SERVICE No. 133 BULLETIN

Piper Aircraft Corporation

SUBJECT: Landing Gear Down Lock Latches

MODELS AFFECTED: PA-23, 23-1 to 23-63 inclusive, 23-65 to 23-111 inclusive

SERVICE BULLETIN 133

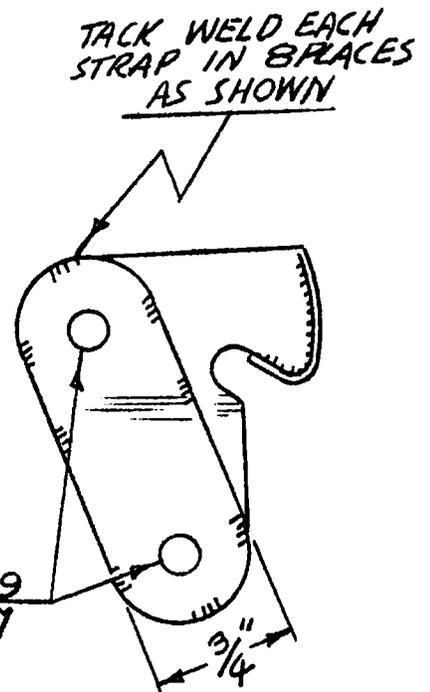
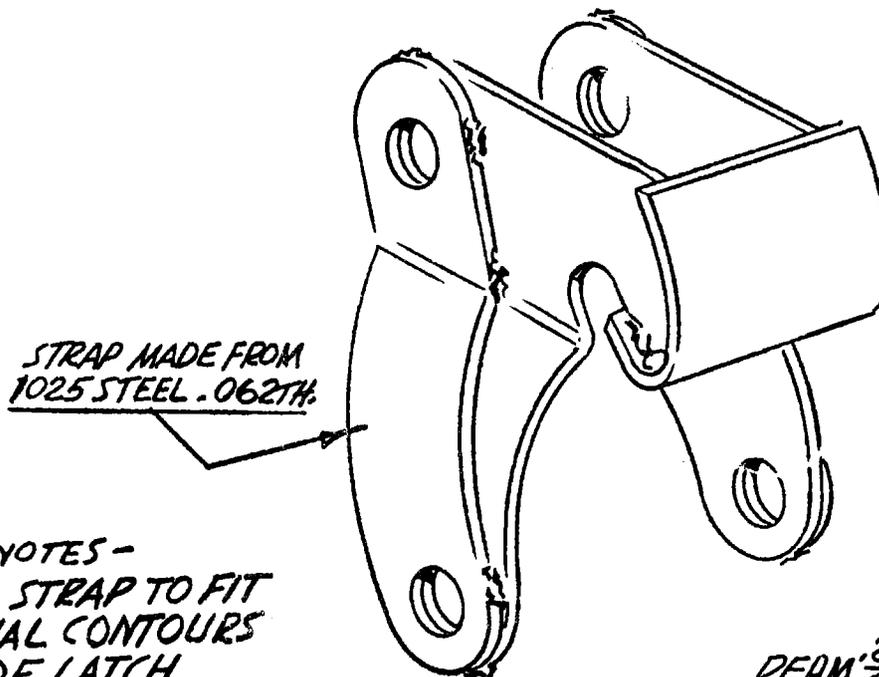
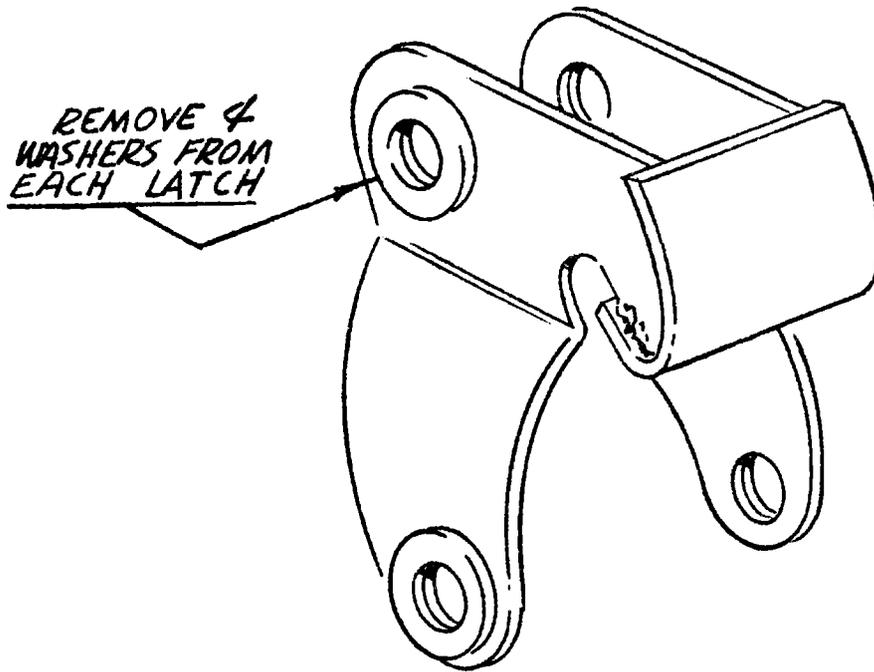
Two Apaches have been found with broken down lock latches and, as yet, it has not been determined what the exact cause is. It may be a weak fitting or the gear actuating cylinder may be out of adjustment. However, to preclude the possibility of cracks starting because of a weakness in the material, it is requested that all three latches be removed and reinforced according to the instructions on the reverse side of this bulletin. It is also requested that the actuating cylinders be adjusted as follows AFTER the latches have been modified.

NOTE: This change is mandatory and down locks must be inspected every 25 hours until the change can be accomplished.

1. Put airplane on jacks.
 2. Remove top rear engine nacelles.
 3. Disconnect the gear actuating cylinder shaft at the point where it attaches to the "down lock latch".
 4. Remove latches and modify per instructions. (Be sure to magnaflux or dye check for welding cracks.)
 5. Reassemble latch to drag link.
 6. With the drag links in the extended position and the "down lock" firmly latched, and with the actuating cylinders fully extended, adjust the self aligning bearing in the end of the shaft so that the attachment bolt will be a "slip" fit in the bearing and the latch.
 7. Remove bolt and screw the bearing out one-half turn (180°).
-

8. Reassemble bearing and latch by "breaking" the drag link slightly and relieving the pressure in the cylinder by putting gear lever in up position and actuating hand pump.
9. After reassembly, actuate the gears several times, check operation of system as well as position indicating lights.
10. Replace nacelles and remove from jacks.

1. FORM STRAP TO FIT ORIGINAL CONTOURS OF LATCH.
2. MAGNIFLUX OR DYE CHECK AFTER WELDING. THIS MODIFICATION APPLIES TO NOSE GEAR AND BOTH MAIN GEARS.
